**MEETING AGENDA OF THE
PLANNING COMMISSION OF THE TOWN OF FRISCO
FRISCO TOWN HALL
1 MAIN STREET
FRISCO, COLORADO 80443
APRIL 16, 2026
5:00 PM**

**PLANNING COMMISSION
STAFF REPORT**

AGENDA ITEM: Planning File No. MODSP-26-0001: A modification to MAJ-24-0005 and CU-24-0001 to make modifications to the proposed building materials, number of decks, number of windows, along with other minor modifications described in the applicant’s narrative.

LOCATION: 200 N 7th Ave / Lot E-2 River Pines Sub Resub Outlot E Replat A River Pines

3. Fascia Wood Siding

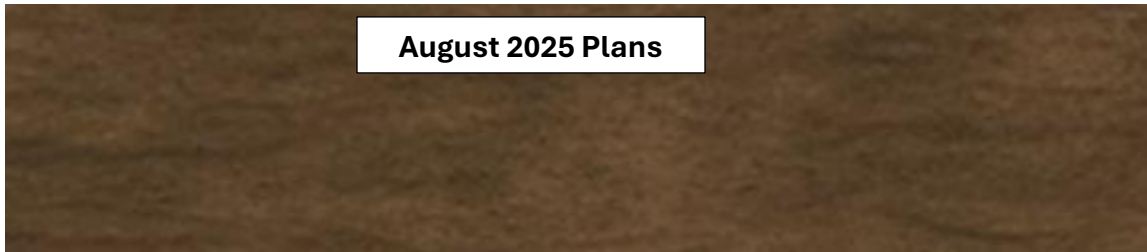
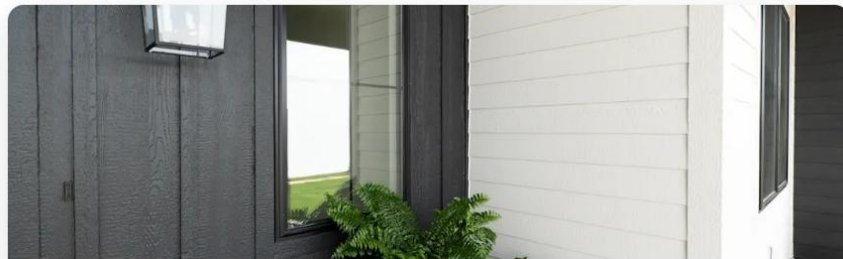
The original application specified fascia siding as a standard cedar product. To maintain consistency with the proposed LP SmartSide horizontal siding, the Applicant proposes using LP SmartSide fascia siding, an engineered wood product designed to replicate the appearance of cedar. The proposed fascia will be the same width and match the color of the originally approved material. The image provided from the August 2025 application of the fascia wood siding in the picture below represents the appearance and finish of the fascia siding as well. Staff notes that this product is commonly used throughout the Town and finds that the proposed change maintains the overall design intent and visual consistency of the façade.

Fascia Wood Siding

The originally specified fascia siding is a standard cedar product. In order to maintain consistency with the proposed LP SmartSide horizontal siding we are proposing to use LP SmartSide fascia siding, which is an engineered wood product designed to replicate the look of cedar. The proposed fascia is the same width and matches the color of the originally selected material. The image provided above for the proposed horizontal siding material is a representative example of the appearance and finish of the fascia wood siding. This product is used throughout the Town of Frisco.

© 2025
SHEET NUMBER:
SP-1.5
BUILDING HEIGHT DIAGRAM AND EXHIBIT

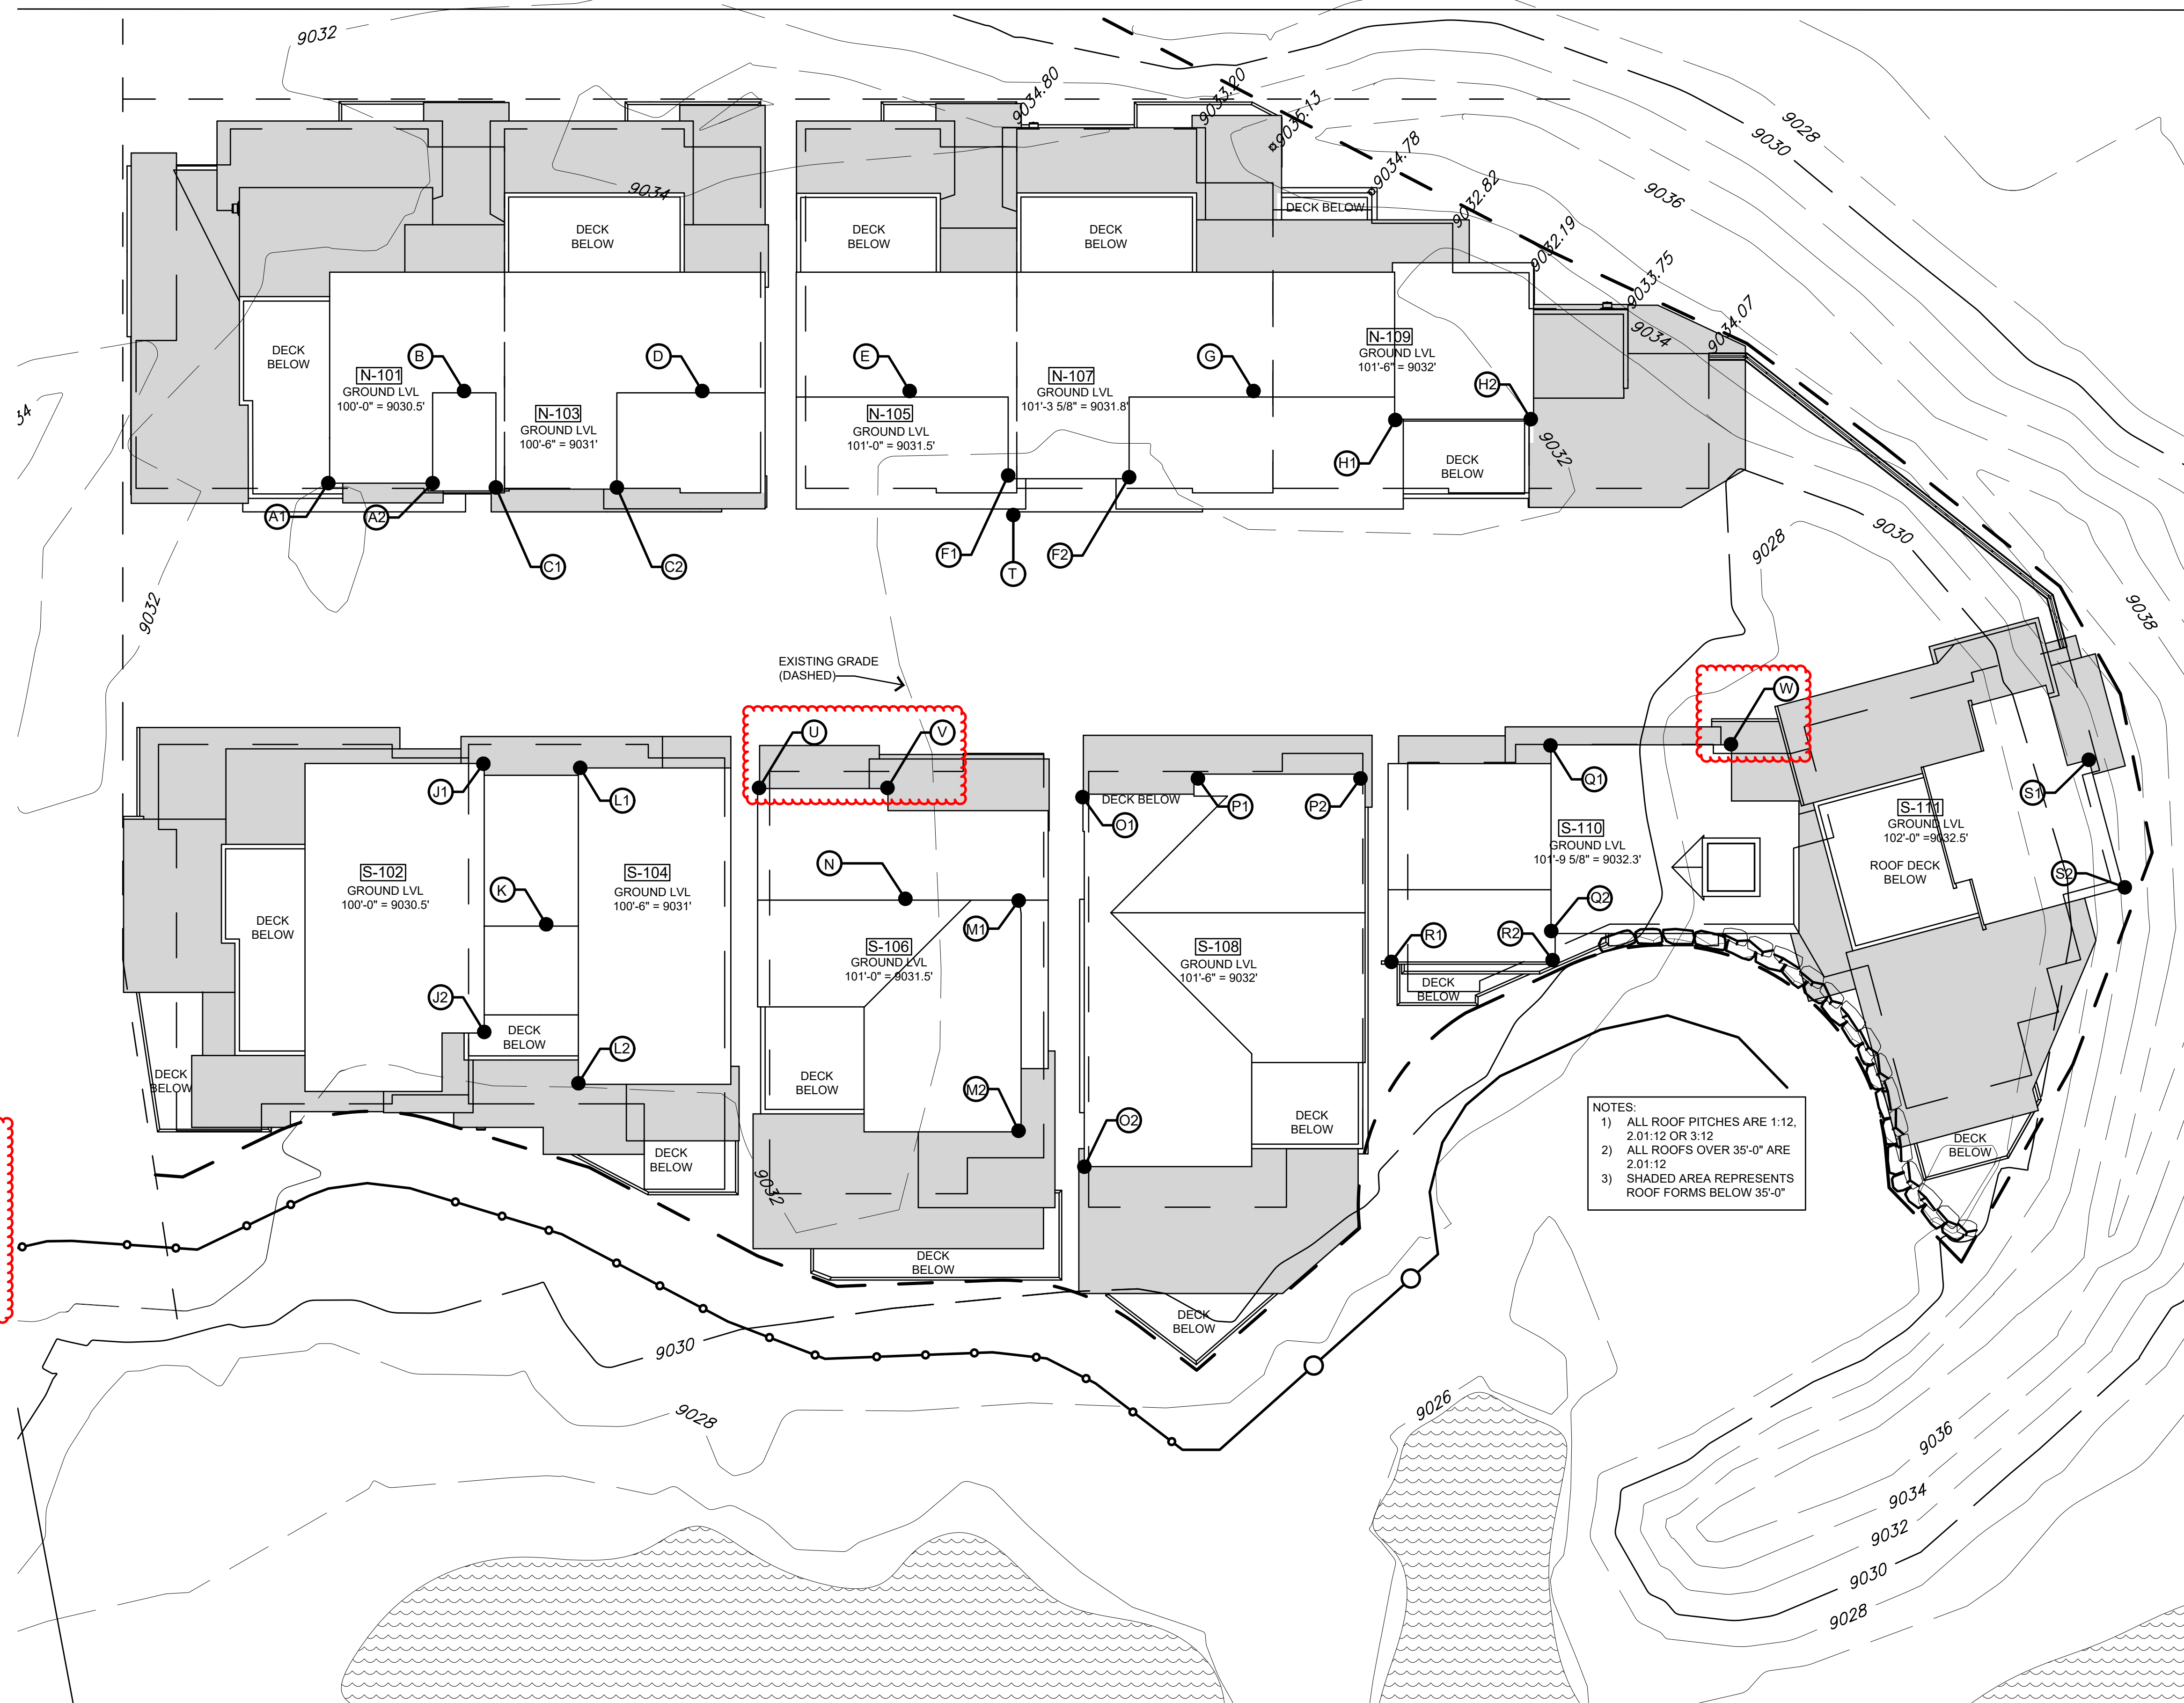
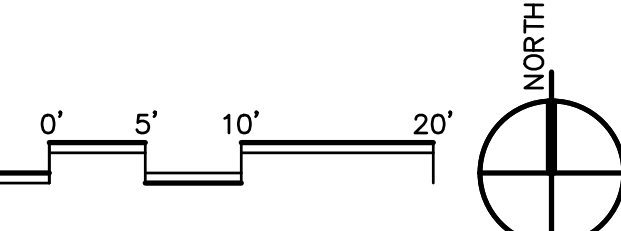
7. Decks and Roof Pitches

The originally approved plans included several units with more than two deck areas. The applicant proposes removing the additional decks so that each unit would have a maximum of two decks. As a result of the deck removal, roof elements are proposed in place of the former deck areas, as illustrated in the submitted plans.

The proposed rooflines associated with these changes are all below 35 feet in height. Under the applicable code provisions, rooflines below this height are permitted to have a pitch of less than 2.01:12. While a lower pitch is permitted, the applicant has indicated that the majority of the newly proposed rooflines would maintain a pitch of approximately 2.01:12. Staff notes that the proposed changes modify certain roof forms associated with the removal of decks but remain within the allowable height and pitch parameters established in the Code. **Please see Attachment A – Application, sheet SP-1.5 - Building Height Diagram and Exhibit for the height table.**

Certain units were originally designed with more than two decks. We are proposing to remove the additional decks so that each unit will maintain a maximum of two decks.

The removal of these decks necessitates the addition of roof elements in their place as indicated in the attached PDF. The newly proposed rooflines are all below 35 feet in height and therefore are permitted to have a pitch of less than 2.01:12 in order to comply with applicable code requirements. Notwithstanding, the majority of the newly proposed rooflines are designed with a 2.01:12 pitch.

ROOF NOTES:
ALL ROOF SECTIONS, WHETHER NEWLY ADDED OR REPLACING EXISTING DECKS, ARE DESIGNED WITH A 2.01:12 ROOF PITCH IN COMPLIANCE WITH THE DEVELOPMENT STANDARDS FOR THIS PROPERTY.
